Subject: Draft NPDES Permit No, MA0101630, Holyoke Water Pollution Control Facility

Michele Duspiva U.S. Environmental Protection Agency – Region 1 5 Post Office Square, Suite 100 (06-4) Boston, MA 02109-3912

Subject Draft NPDES Permit No, MA0101630, Holyoke Water Pollution Control Facility

Calculator for ALUMINUM Metals Reasonable Potential Daily Avg

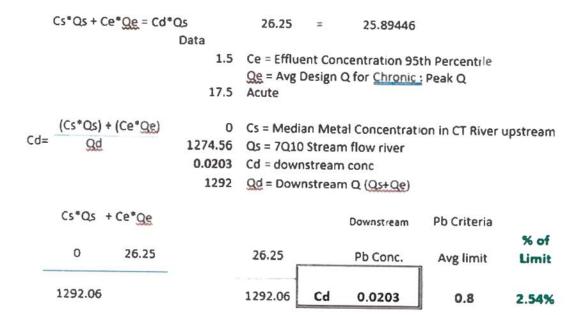
- 1. Page 3 of 35, Effluent Limitations and Monitoring Requirements:
 - a. Total Aluminum, Copper, and Lead. It is unclear as to why copper and lead are limited since the discharge does not have reasonable potential to violate the applicable water quality standards. (see Attachment A). The Aluminum Water Quality limit is set at 87 ug/l which the EPA used as the WQ maximum exposure receiving water concentration. The Aluminum Calculator (Version 2.0) is the appropriate criteria to use in this calculation. Appendix B of the Draft Permit includes both the 87 ug/l limitation and the Aluminum Calculator Chronic Concentration of 290 ug/l. EPA adopted the Aluminum Calculator in 2018 and the State of Massachusetts also approved this application on November 11, 2021³. As outlined in Appendix A, the Aluminum Criteria value would be 27.22% of the WQ criteria and therefore there would be 'No Reasonable Potential' to violate WQ."

It should also be noted that there are no technology-based effluent standards for these metals that are applicable to POTWs. Instead, they are responsible for regulating their industrial users to prevent metals and toxics from causing treatment inhibition, problems with biosolids disposal, and protecting receiving stream water quality. As Holyoke's data suggest, they are adequately limiting these industries. By setting the effluent discharge limit at the 95th percentile of effluent discharge concentrations, EPA seems to be applying technology-based limits for these parameters. EPA does not comply with the reasonable potential calculation as outlined in Appendix B of the draft.

EPA notes in the fact sheet, "As shown, the 95th percentile of the effluent data (Ce) for each metal results in a downstream concentration (Cd) significantly below the relevant criterion." This is the very definition of "no reasonable potential to cause or contribute to violations of water quality standards.

With no regulatory basis for technology-based effluent limits and no reasonable potential for the discharge to cause or contribute to violations of the instream standards for aluminum copper and lead, Holyoke respectfully requests that effluent limitations for these parameters be removed from the permit.
